Subject: AP1000 COL Response to Requests for Additional Information (TR 3)

## Response to Request For Additional Information (RAI)

RAI Response Number: RAI-TR03-015  
Revision: 1

Figure RAI-TR03-15-1-Strain-iterated shear wave velocity profiles

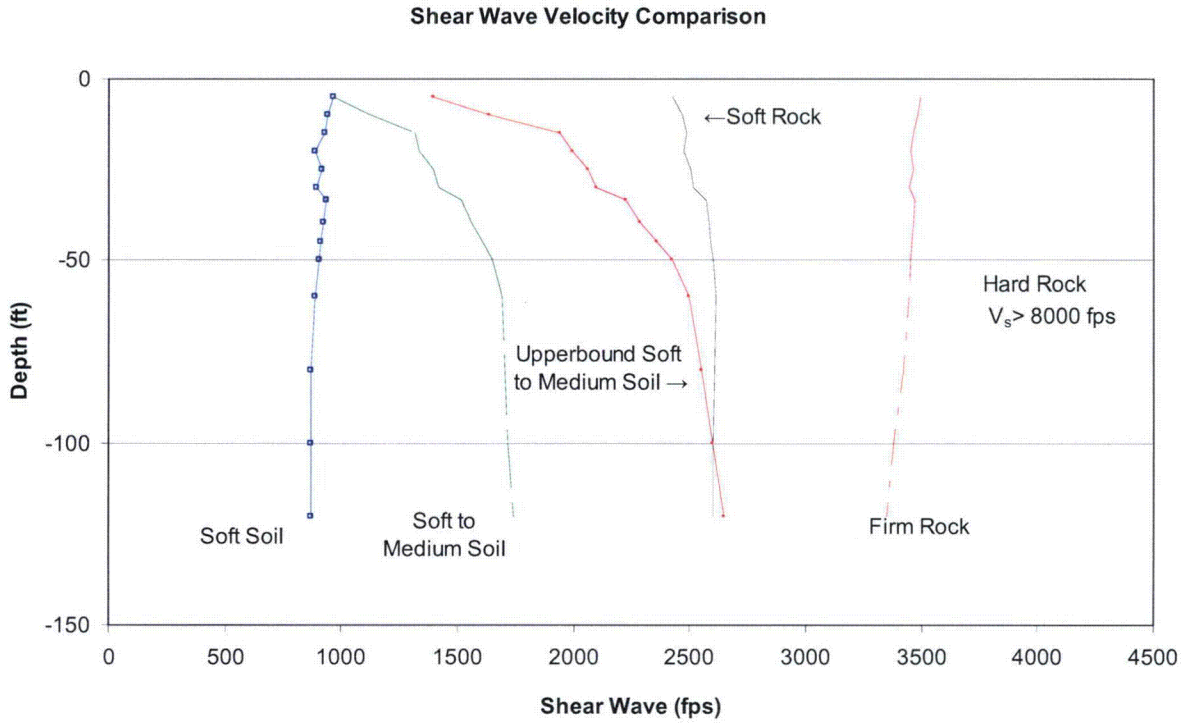
In Page 48 of 154, Westinghouse illustrated that some effects (water table, soil layering, soil degradation model, etc.) are not significant to the seismic response of the nuclear island (NI) structures. Because these results are applied for the AP1000 design, the staff requests Westinghouse provide technical basis for making these conclusions. In addition, Westinghouse needs to demonstrate the combination of these effects is also insignificant to the seismic response of the NI structures.

Westinghouse has addressed soil degradation in RAI-TR03-10. Tables of strain-iterated shear wave velocity used in the generic analyses are shown. Figure RAI-TR03-15-1 shows the bounds of these strain-iterated shear wave velocity profiles. The combination of effects of the different soil parameters is reflected in these bounds. Figure RAI-TR03-15-2 shows how a COL applicant could demonstrate that the site is enveloped by generic seismic design basis. The applicant would define its site geotechnical parameters as defined in DCD Section 2.5 and in a foundation interface report in which the applicant would make its case of why the site is within the bounds of the AP1000 generic analyses that have been considered in this technical report. These parameters would include the soil profiles used in the PSHA analyses, which

could then be compared to Figure RAI-TR03-15-1. Subsequent discussions between the COL applicant and the NRC may uncover a parameter for which more justification is required to show that the impact of this parameter on the response is small. This justification could be done with the AP1000 2D model. An example of how a 2D parametric study would be used is shown in Figure RAI-TR03-15-3 and RAI-TR03-15-4. If the parametric 2D SASSI studies show that the effect could be significant (e.g., 90% of the design spectrum, see Figure RAI-TR03-15-4) when compared to the 2D design spectra, a 3D SASSI study would then be performed. If the 3D SASSI analyses show some exceedances at the critical locations, the applicant would then proceed to show that sufficient margin exists in the design to accommodate these exceedances.

Figure RAI-TR03-022-1-Relative Displacement of Node 3360, top of Shield Building

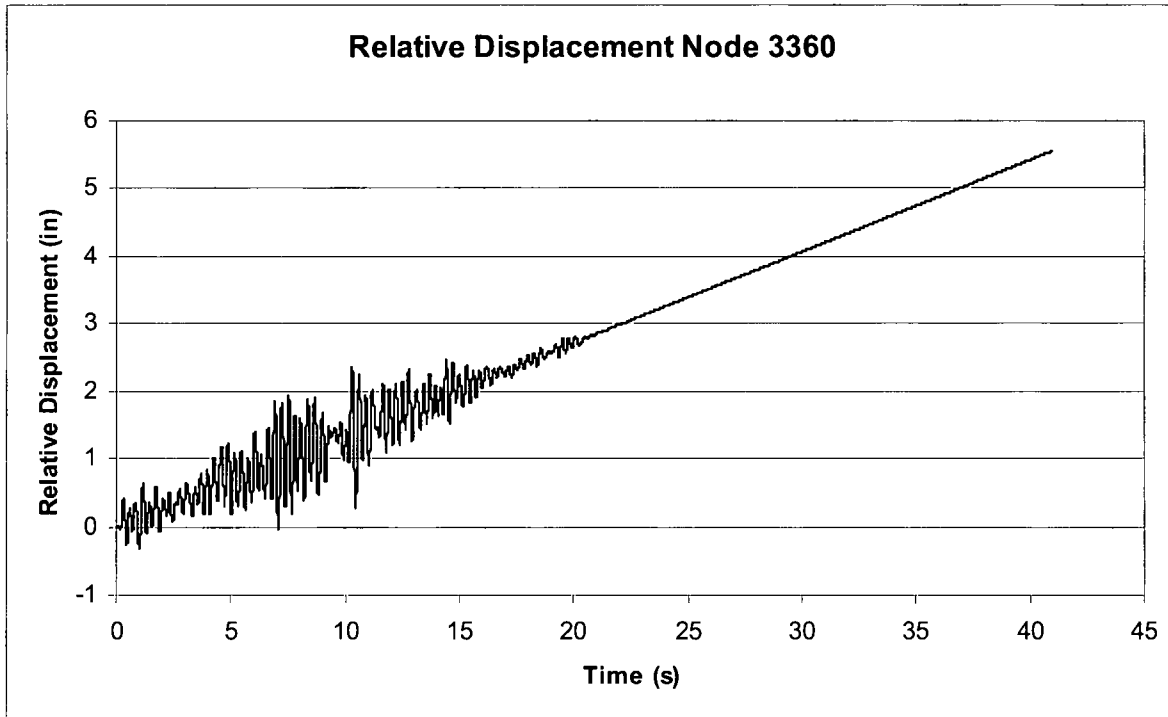
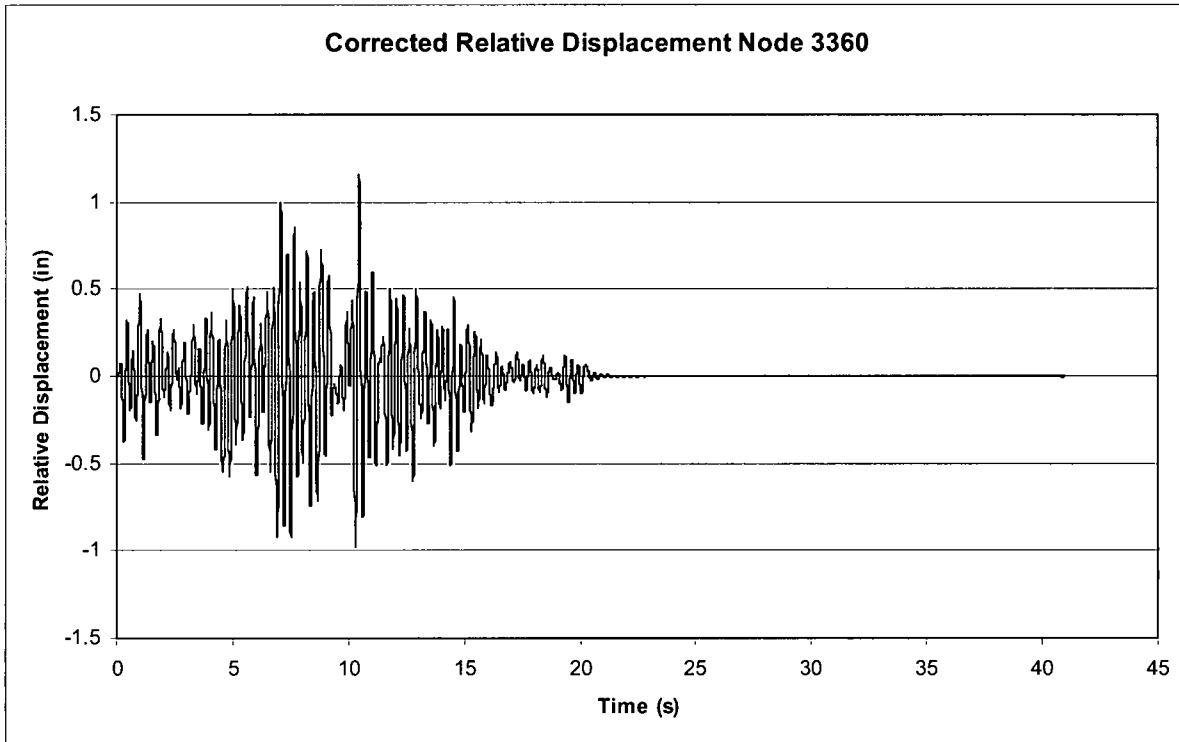
- a. Are the deflections in the tables a consistent set, based on the worst-case time history result, or are they an envelope of maximum deflections from all the time history results?
- b. How do these tabulated deflections compare to the corresponding deflections obtained from the equivalent static acceleration analyses? Please provide a tabulated comparison, and an explanation of any significant differences.

- a. Deflections have been developed using the model with the robust shield building design. These displacements for the soil and hard rock cases have been obtained relative to the translation of a reference node at the bottom of the foundation and near the center of the basemat. Coordinates of this reference node are  $x= 993.00$  ft,  $y= 986.00$  ft and  $z= 60.50$  ft. The deflections have been revised to remove drift. The absolute displacement time histories are calculated from the nodal time histories accelerations. When the relative displacements are plotted there is a constant slope as shown in Figure RAI-TR03-022-1. To correct this drift, the slope of the relative displacement multiplied by the time is subtracted from the relative displacement at each time step. Presented in Figure RAI-TR03-022-2 is the drift corrected relative displacement.

Figure RAI-TR03-032-1 — FRS Comparison at Base of SCV on CIS at RPV Center

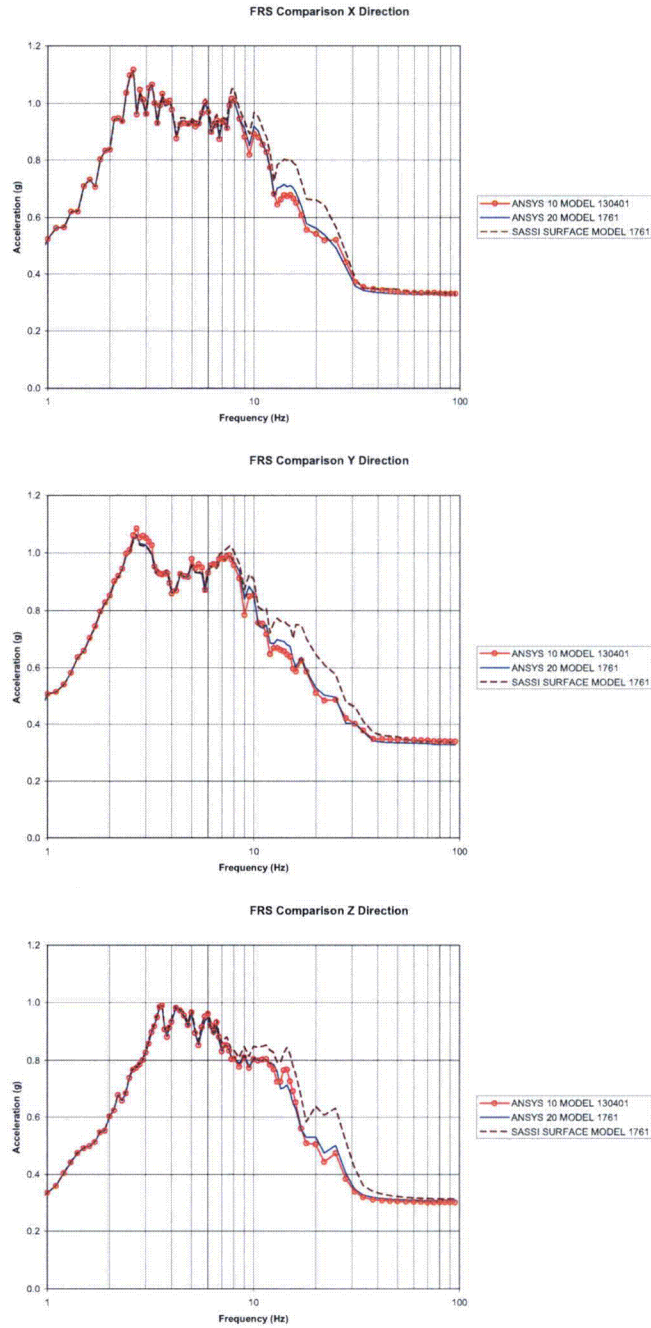
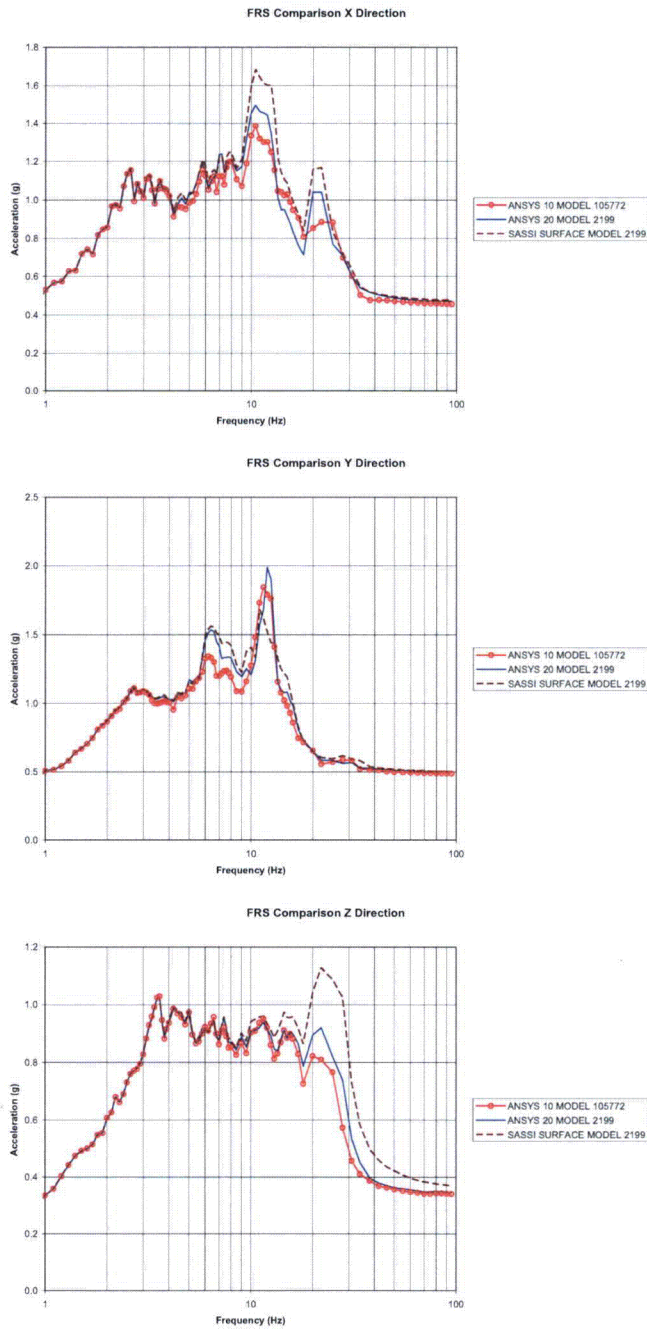
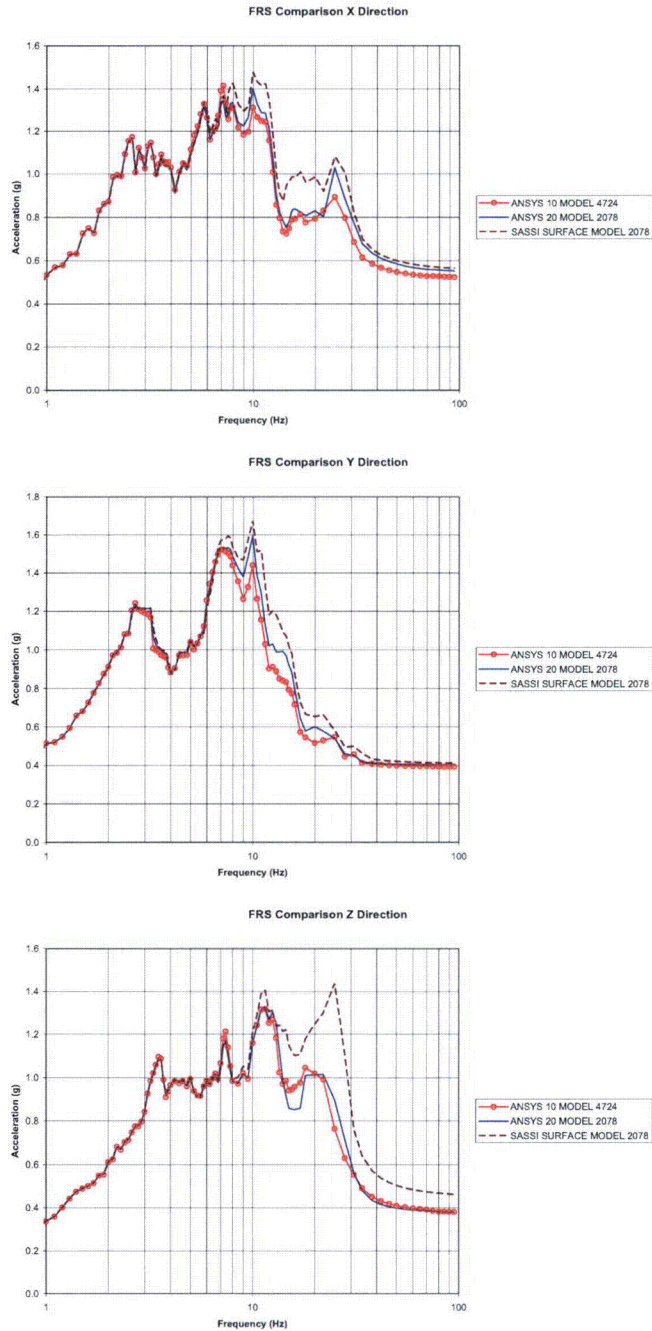
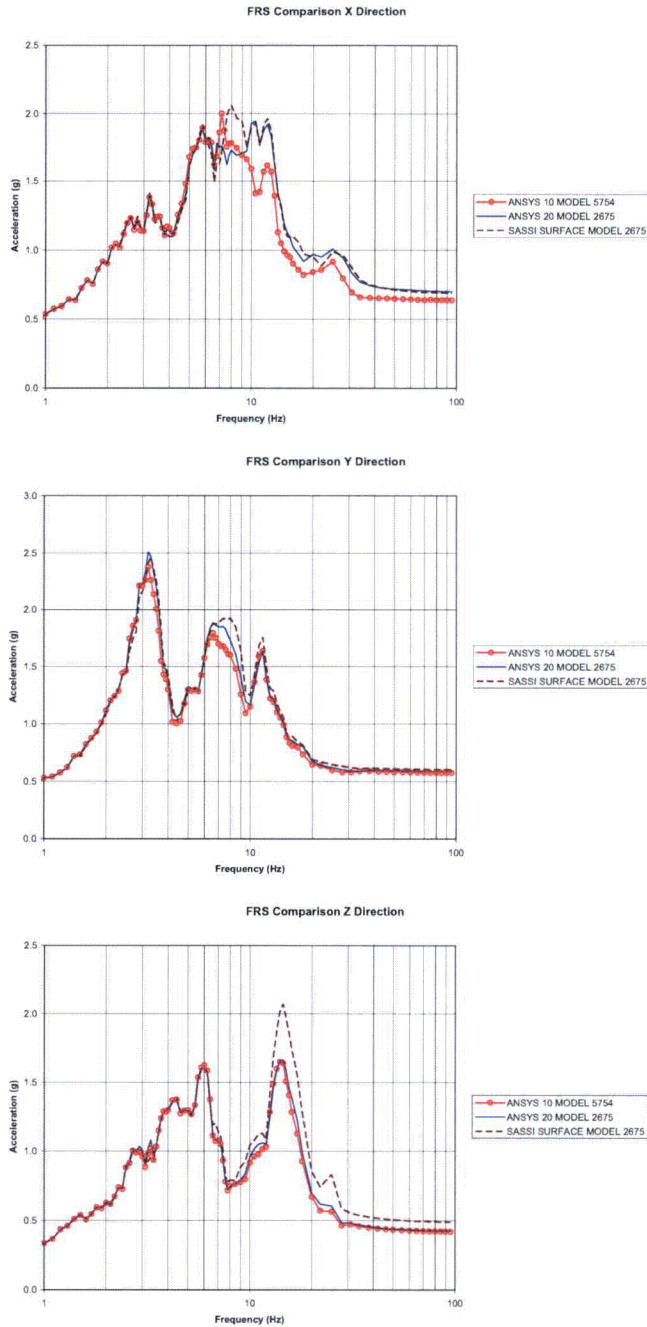
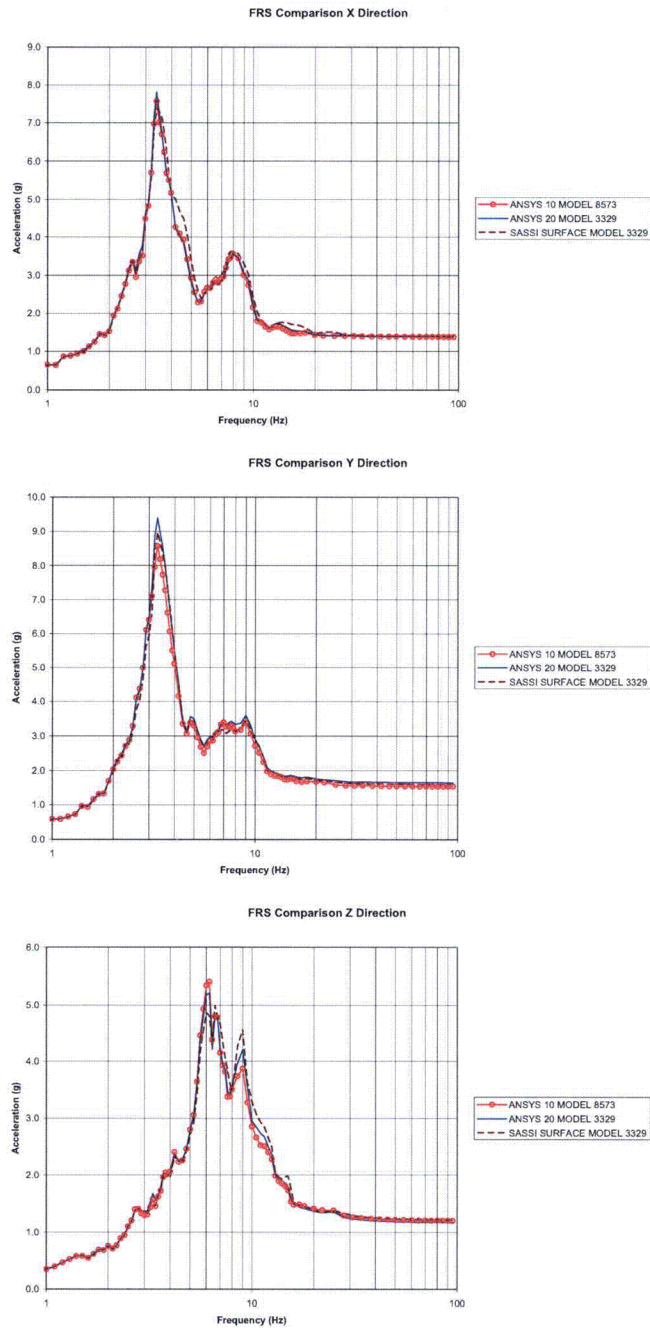
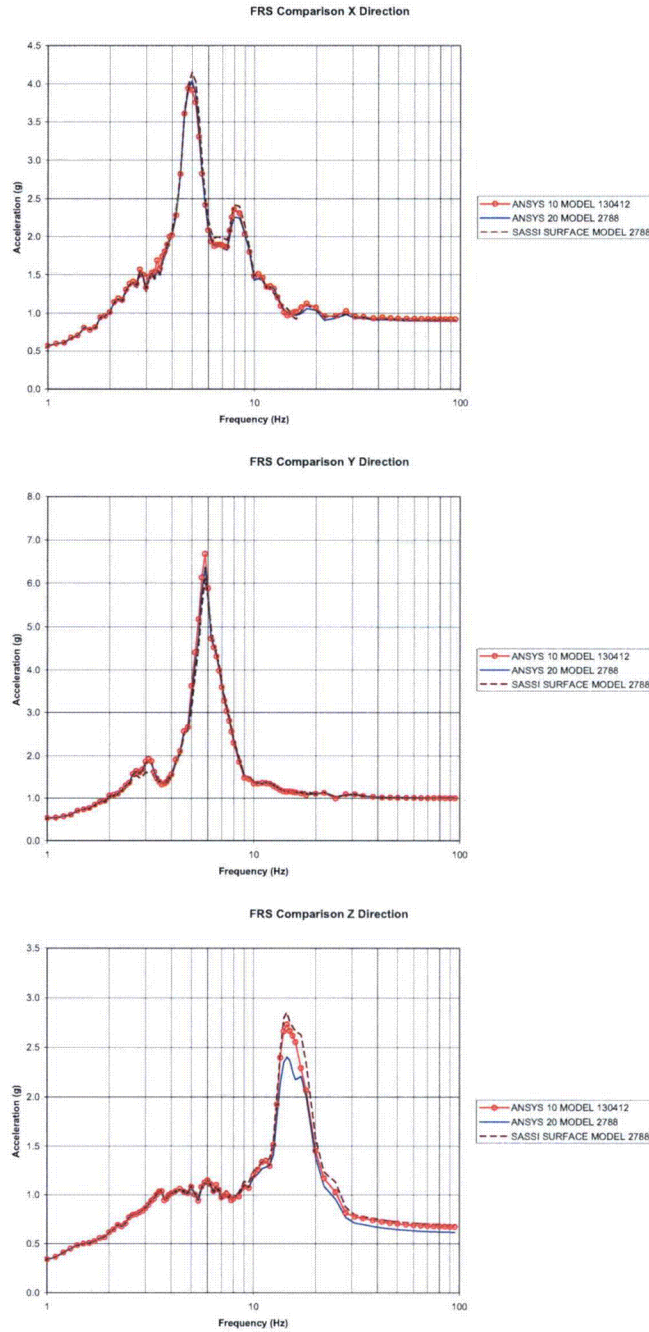
NI20 model results above 10 hertz for all site conditions, including a hard rock site. Is the NI20 grid sufficiently refined to accurately predict response above 10 hertz? Have any SASSI soil site analyses been performed using a refined grid comparable to the NI10 model, to study the effect of element size on the solution results?

- c. Explain what studies were performed to establish that the NI10 model refinement is sufficient to accurately account for high frequency response effects at all critical locations. It is not obvious from the results shown in Figure C-1 that convergence with element size has been achieved.

- c) The NI10 model is described in DCD subsection 3.7.2 (Item 5) and is the basis for the vertical floor response spectra for hard rock. The model was reviewed and accepted as part of the hard rock design certification. During development of the model detail studies with greater element refinement were performed for the floor above the control room and the adjacent bays to confirm the adequacy of the model.

Location	NI10 Node	NI20 Sassi	Figure ANSYS & SASSI FRS Comparison	General Area	Elevation (feet)
CIS at Reactor Vessel Support Elevation	130401	1761	RAI-TR03-032-1	RPV Center	100.00
CIS at Operating Deck	105772	2199	RAI-TR03-032-2	SG West compartment, NE	134.25
ASB NE Corner at Control Room FloorCeiling	4724	2078	RAI-TR03-032-3	NE Corner	116.50
ASB Corner of Fuel Building Roof at Shield Building	57454	2675	RAI-TR03-032-4	NW Corner of Fuel Bldg	179.19
ASB Shield Building Roof Area	8573	3329	RAI-TR03-032-5	South side of Shield Bldg	327.40
SCV Near Polar Crane	130412	2788	RAI-TR03-032-6	SCV Stick Model	224.00
